Memorandum

subject Response to Comments on Initial Study/Mitigated Negative Declaration
Napa Canyon LLC Vineyard - #02253 Erosion Control Plan

This document provides the County's responses to comments received on the Initial Study/Mitigated Negative Declaration, dated December 2004 (2004 IS/MND) (ESA, 2004) and Technical Appendix: Geology and Hydrology (ESA, 2004) for the Napa Canyon LLC Vineyard #02253 – Erosion Control Plan Agriculture (#02253-ECPA) project.

Figure 1. Topographic map of the proposed vineyard.

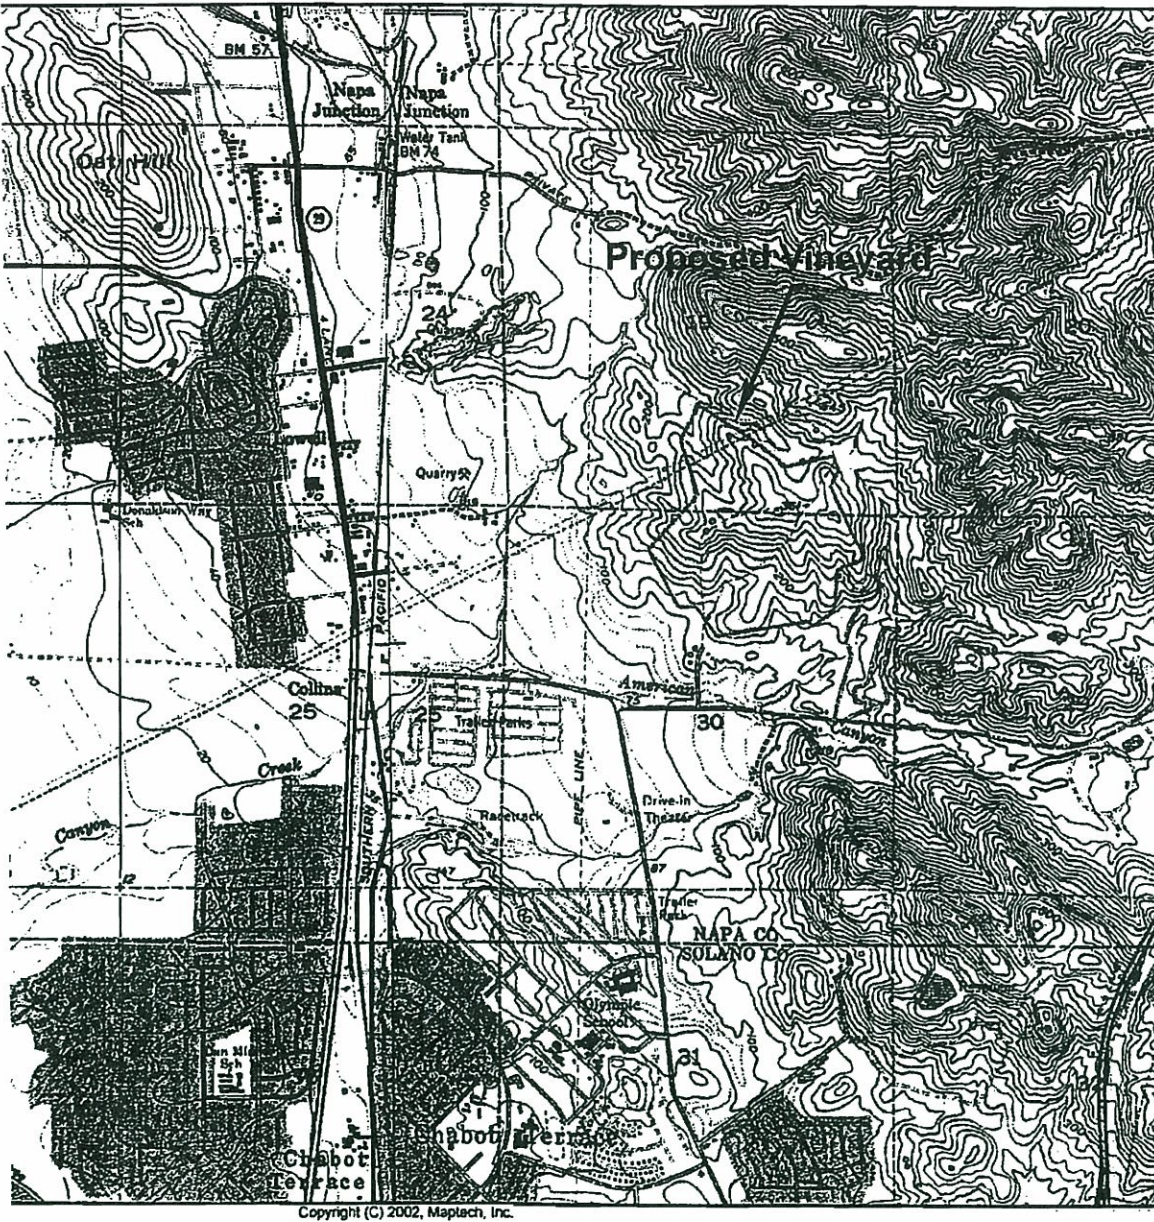
My only comment (which has nothing to do with the evaluation, per se) is that Figure 1 should recognize the existence of the City of American Canyon. | C-1

Figure 1 is a topographic map showing the location of the proposed vineyard.

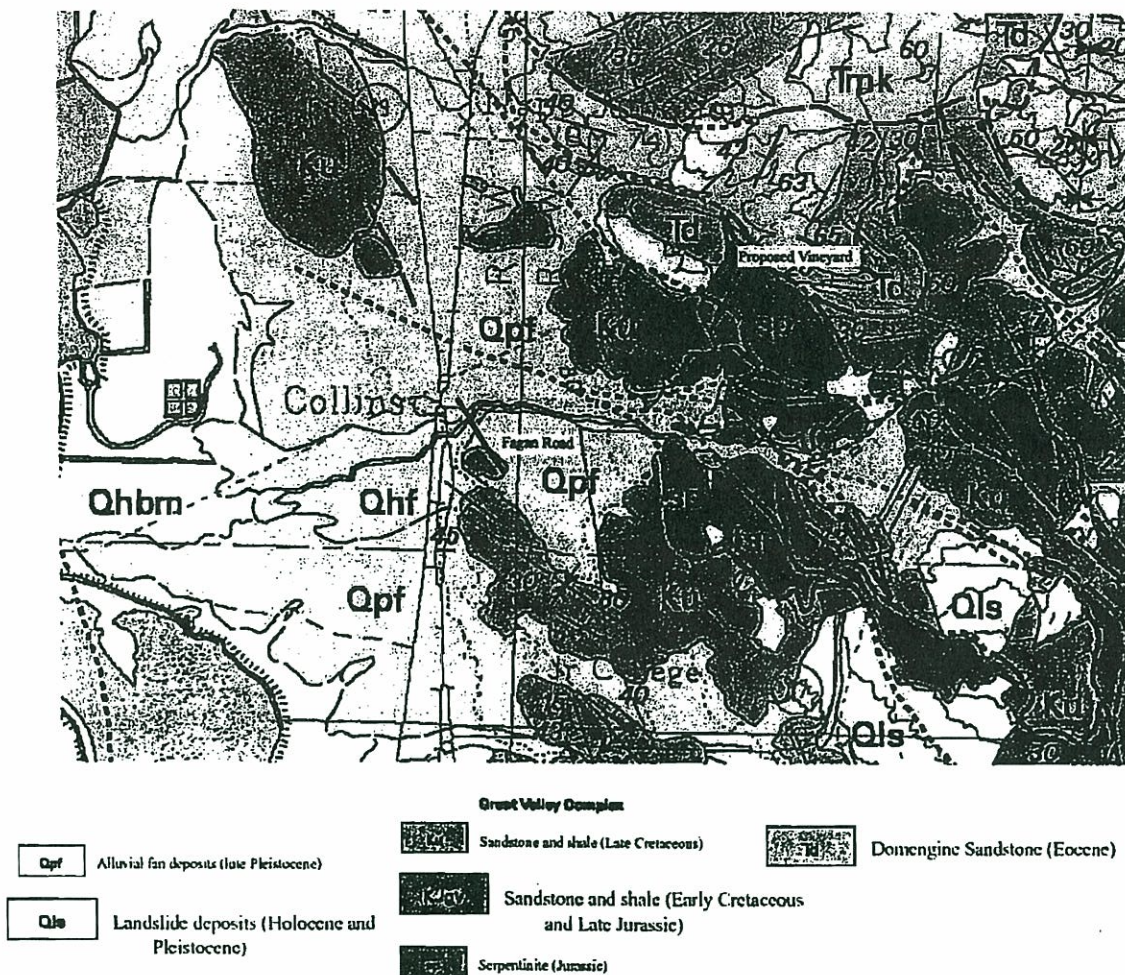
Figure 3 shows the geologic map (Graymer, Jones and Brabb, 2002) in the vicinity of the proposed vineyard. The proposed vineyard is underlain by primarily Great Valley Complex sandstone and shale (late Cretaceous). The southeast edge of the proposed vineyard is underlain by serpentinite (Jurassic). Alluvial fan deposits are found between the proposed vineyard and American Canyon Creek.

The soil map shown in Figure 2 shows that an area of soil mapping unit 154 (Henneke gravelly loam – derived from serpentine) is located just to the north and west of the unnamed tributary to American Canyon Creek. The geology map in Figure 3 appears to confirm the presence of the serpentinite. The serpentinite outcrop and the associated Henneke gravelly loam appears to be mostly in vineyard Block H but may extend into Blocks G and E may.

If a site investigation discovered that the soil map shown in Figure 2 and the geology map shown in Figure 3 are incorrect in regards to the presence of the serpentinite and Henneke soil, this fact should be discussed in the Initial Study.

The USLE soil loss analysis (see Response to Comment B-3) accounts for the portions of vineyard in Sub-Basin 2 that are underlain by the serpentine soils (the Natural Resources Conservation Service [NRCS] classifies the serpentine soils as Henneke gravelly loam). The higher erodibility of Henneke soils are reflected in the weighted K (soil erosiveness) value for Sub-Basin 2. K values used in the updated soil loss analysis match the K values assigned for specific USDA SCS soil types in *The Universal Soil Loss Equation, USLE, Special Applications for Napa County, California* (USDA, 1994). In cases where several soil types occur within an individual sub-basin, the K values were weighted to reflect these soil conditions.
